# 2016 MX-5, 2016 CX-3, and new 2016 CX-9 BLIND SPOT MONITORING (BSM) SYSTEM CHANGE

# MULTI-MODEL (EQUIPPED WITH MAZDA CONNECT) NAVIGATION AND/OR SIRIUS XM RADIO INOPERATIVE

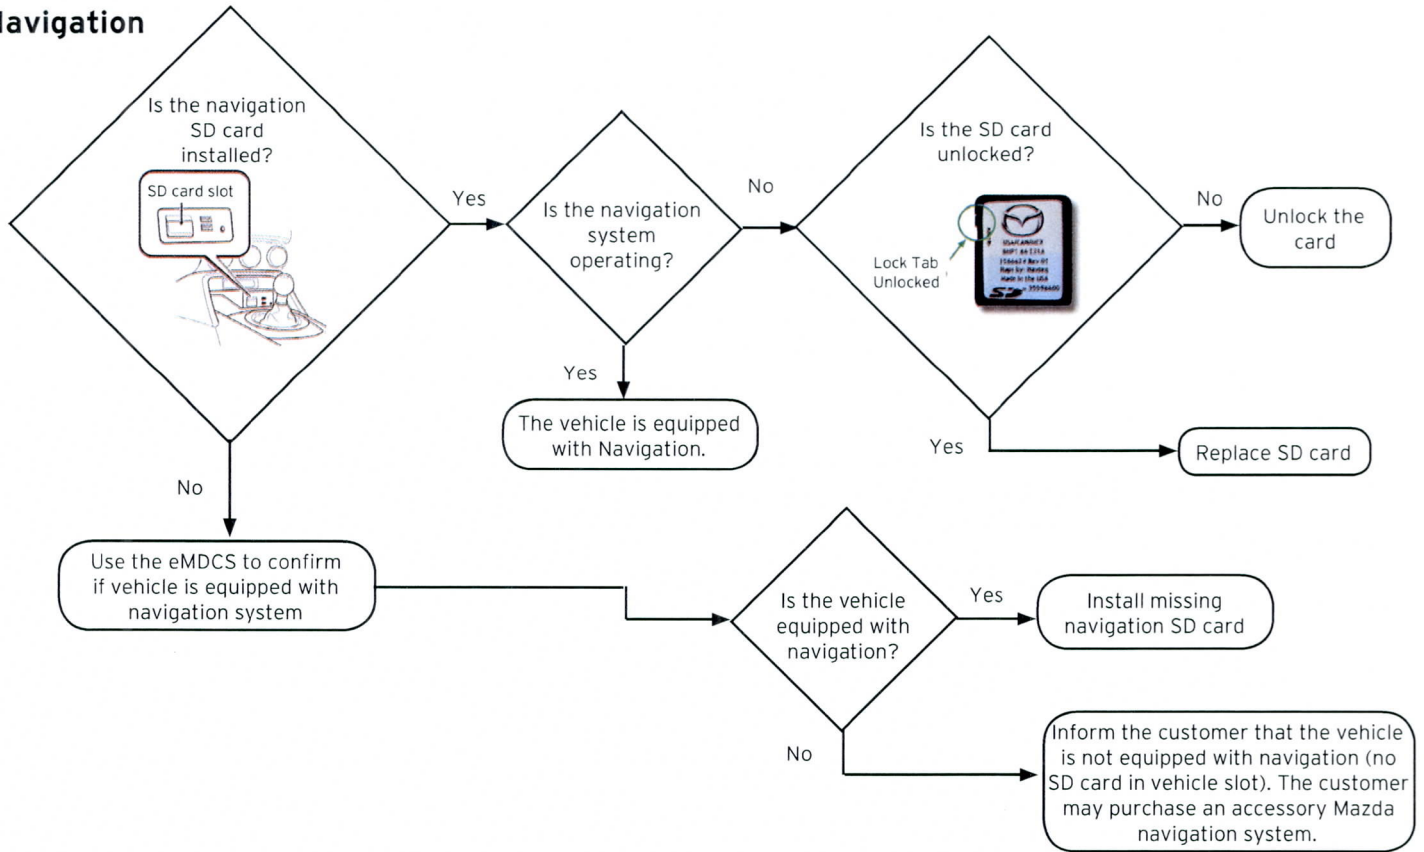
The 2016 MX-5, 2016 CX-3 and new 2016 CX-9 BSM system vehicle detection has changed. Although the overall function is the same as previous vehicles, vehicle detection is different.

Other Mazda Vehicles Equipped With BSM	2016 CX-3, 2016 MX-5 and new 2016 CX-9*
Detection area behind vehicle	7 m (23 ft)	<ul style="list-style-type: none"> <li>50 m (164 ft)</li> <li>Within 5.5 seconds of vehicle approaching from rear</li> </ul>
Vehicle Detection		
BSM Indicator OFF	<ul style="list-style-type: none"> <li>No vehicle detected in the MONITORED AREA</li> <li>High speed difference with vehicle in the MONITORED AREA.</li> </ul>	<ul style="list-style-type: none"> <li>No approaching vehicle in the ALERT AREA</li> <li>Vehicle in the ALERT AREA is cruising at a lower speed</li> </ul>
BSM Indicator ON	<ul style="list-style-type: none"> <li>Vehicle detected in the MONITORED AREA</li> <li>Low or similar speed difference with vehicle in the MONITORED AREA.</li> </ul>	<ul style="list-style-type: none"> <li>Detected approaching vehicle in the ALERT AREA</li> <li>Approaching vehicle reaching the rear of your vehicle within 5.5 seconds</li> <li>Vehicle in the ALERT AREA is cruising at same speed or higher</li> </ul>

BSM Indicator Flashing	<ul style="list-style-type: none"> <li>Turn Signal Switch ON and vehicle detected in the MONITORED AREA</li> <li>Turn Signal Switch ON and low or similar speed difference with vehicle in the MONITORED AREA.</li> </ul>	<ul style="list-style-type: none"> <li>Turn Signal Switch ON and detected approaching vehicle in the ALERT AREA</li> <li>Turn Signal Switch ON and approaching vehicle reaching the rear of your vehicle within 5.5 seconds</li> <li>Turn Signal Switch ON and vehicle in the ALERT AREA is cruising at same speed or higher</li> </ul>
Special Service Tool (SST)	Reflector (*Including new 2016 CX-9) 	Doppler Simulator (2016 MX-5 and 2016 CX-3 only)
